*Huntington Park Clear  
by Timberline  
S. J. Morrison Dec.*

*Proposed Road*

**657-A**

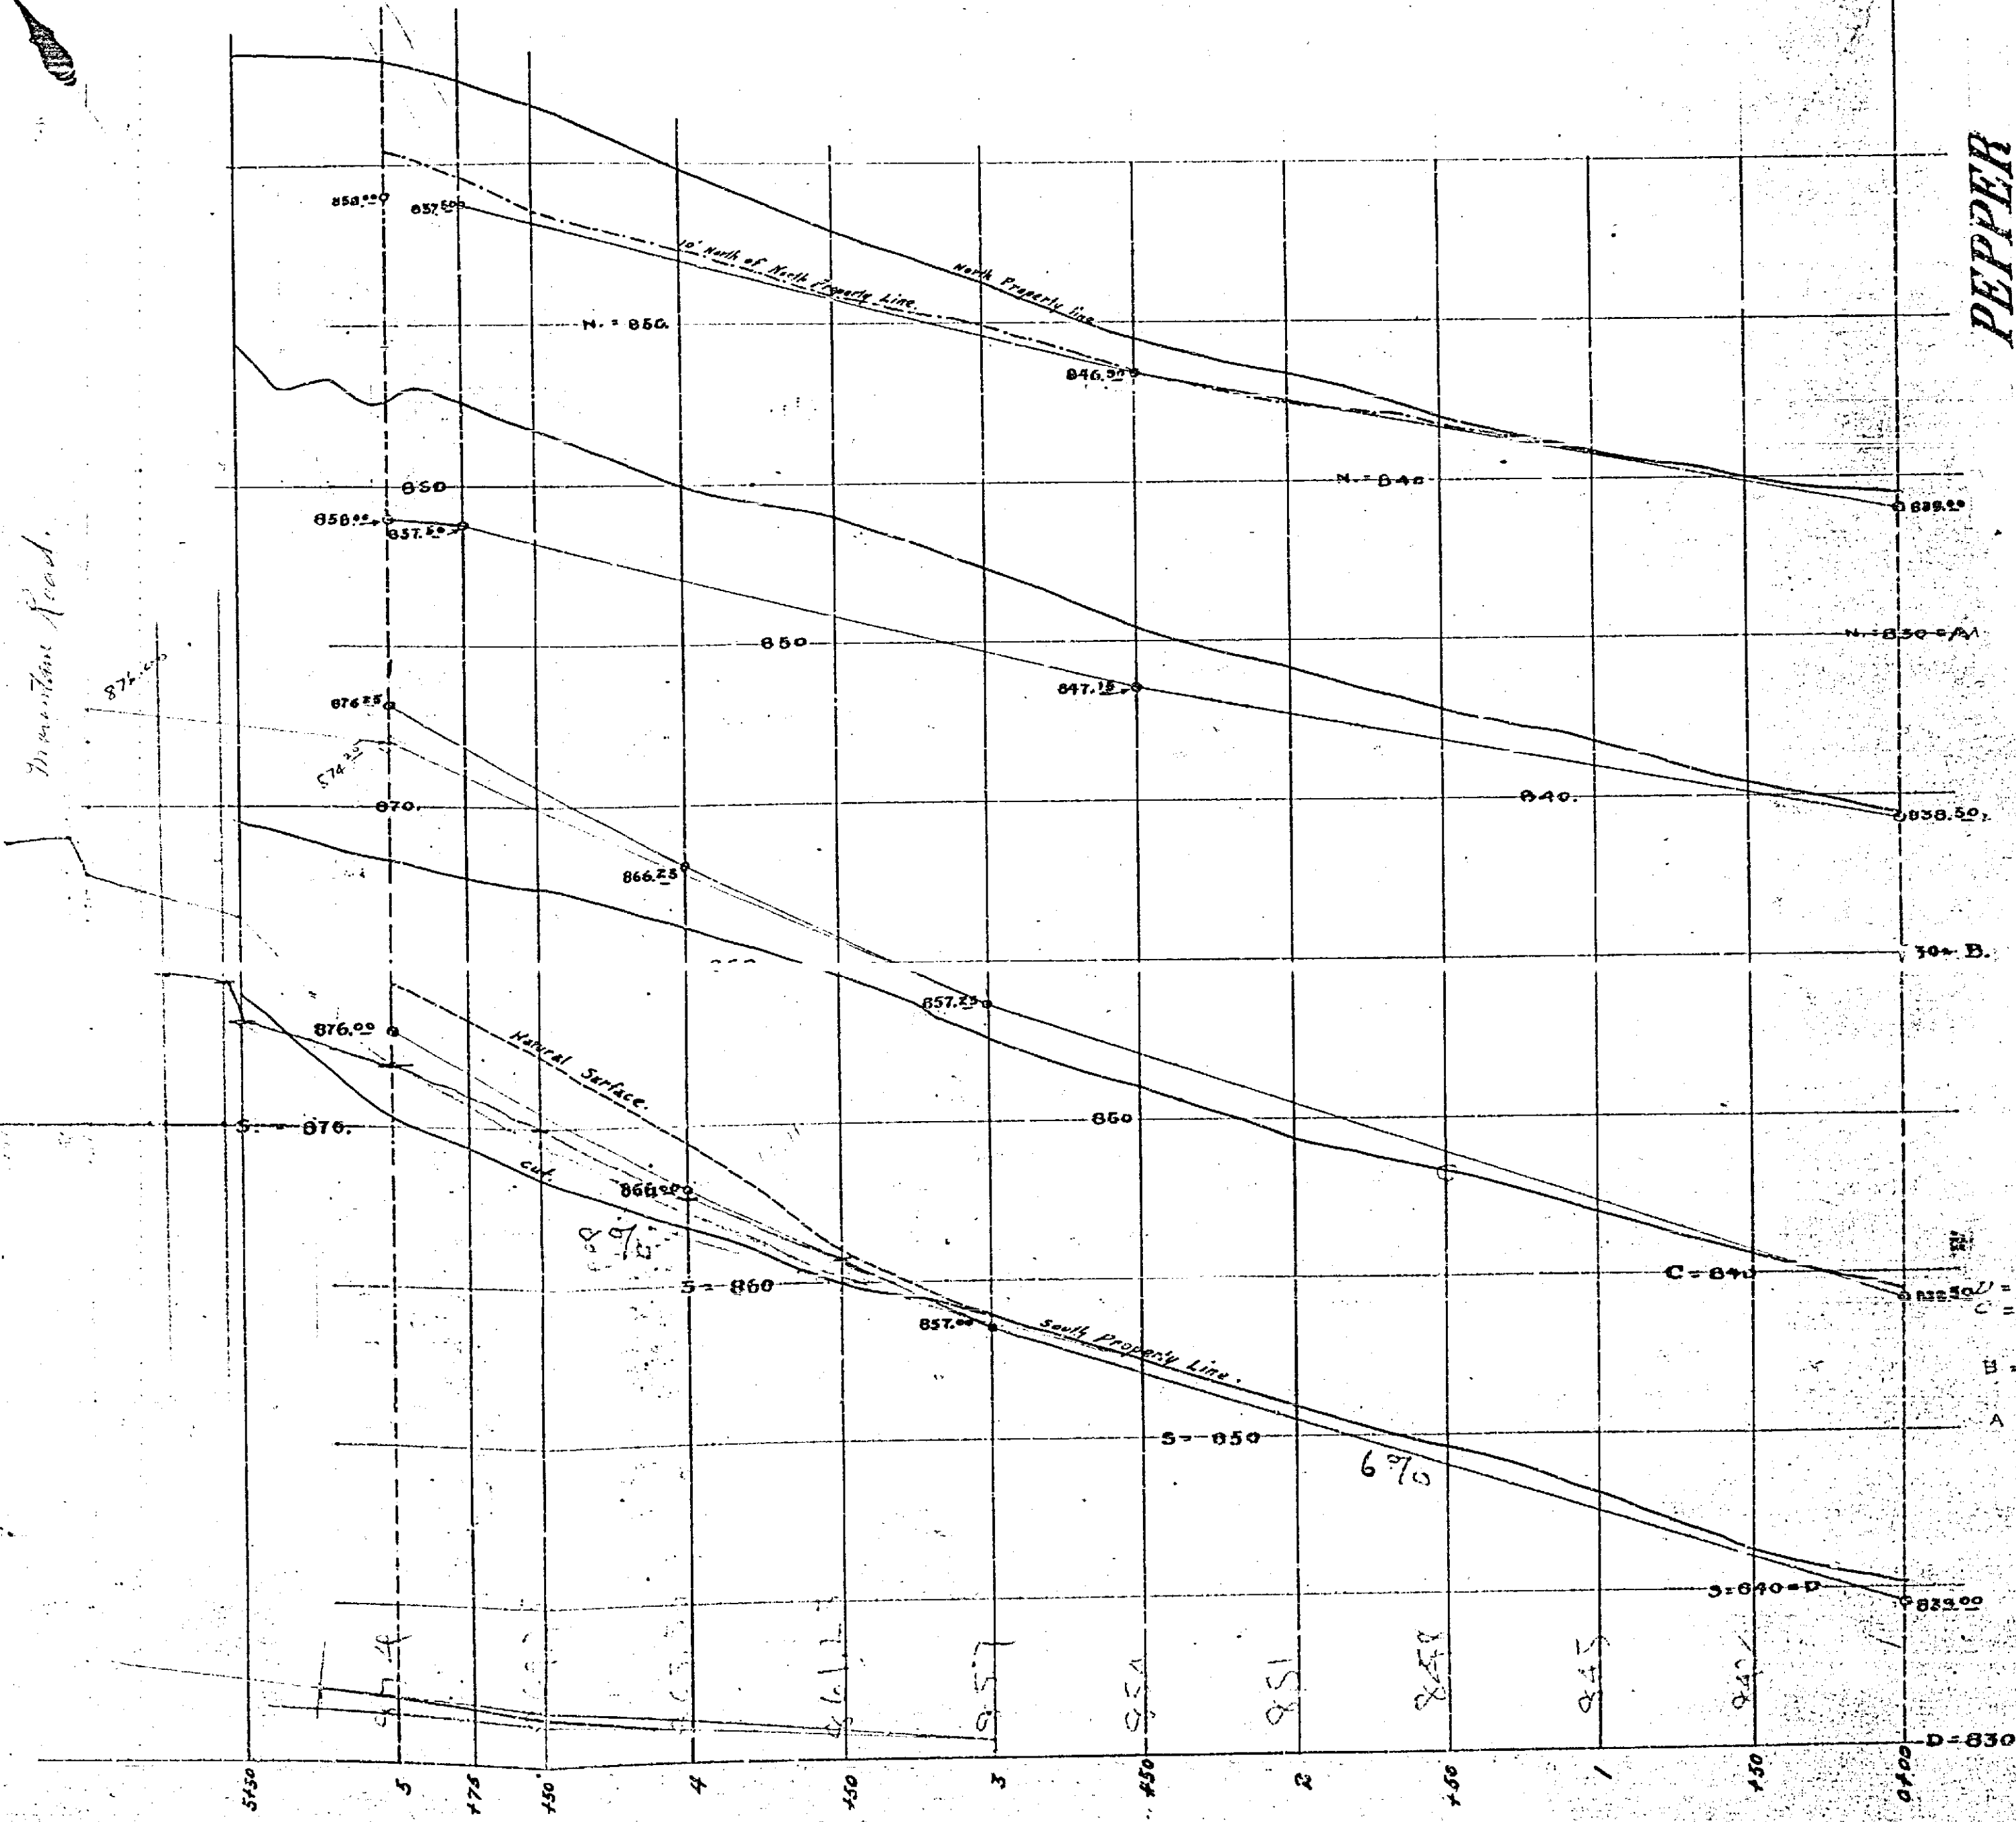
*Ch. has to be  
over 100'*

*Note - not  
exceed 500' in area*

*I see no objections to a two foot gutter  
on south side of high roadway instead of  
customary three foot, as grade is enough  
to carry water. S. J. Morrison, Mayor  
Dec. 19, 1906*
